401 W GEORGIA STREET (COMPLETE APPLICATION)  
DP-2017-00119 - DD

**DEVELOPMENT PERMIT STAFF COMMITTEE MEMBERS**

- **Proposal:** To develop a 9 storey office building over two levels of existing underground parking accessed from the lane and seeking a 10% increase in the Floor Space Ratio using a Heritage Density Transfer of 3,822 sq. m.

Figure 1: Comparative of 7.0 FSR shown, and 7.7 massing shown in red dashed outline.

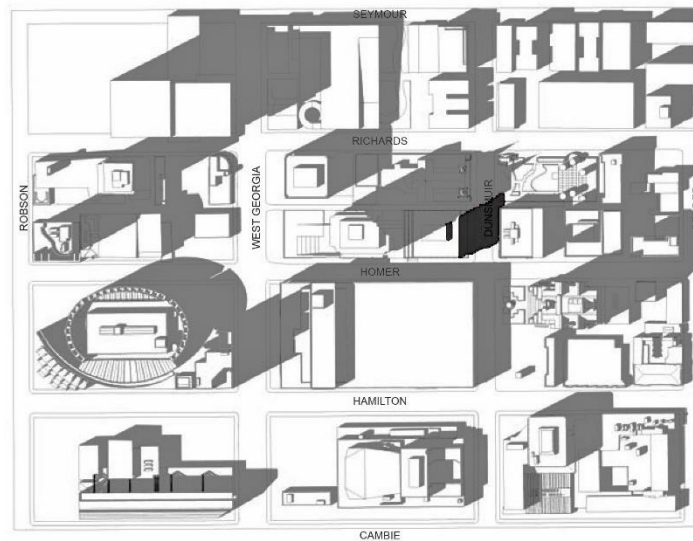
The proposed height of 42.96 m (104.94 ft.) measured from the base surface of the site is well within the height prescribed in the DD ODP. The site is subject to 2 view cones including: E1 and 9.1. The proposed height is below these view cone parameters; no public views, therefore, are affected through the proposal. In terms of the response to the streetscape, and the compatibility with the context, the proposal is representative of a careful study of the existing buildings that surround the site. The shifts in the building massing, floor plate clusters, are derived from various heights of 411 Dunsmuir, the Post Office and the Holy Rosary Cathedral. Figures 1 and 2, below, delineate schemes at 7.0 and 7.7 FSR, with the dotted line showing the proposed massing at 7.7 FSR.

Comparative shadow studies were undertaken by the proponent and reviewed by staff. The transfer of an additional 10% (3,822 sq. m.) will result in an additional 12 m in height, and two stories to the proposal (the difference between 7.0 FSR and 7.7 FSR). Staff reviewed the incremental shadow impact caused by the additional proposed two floors and concluded that the impacts to the Cathedral Square Park are not significant.
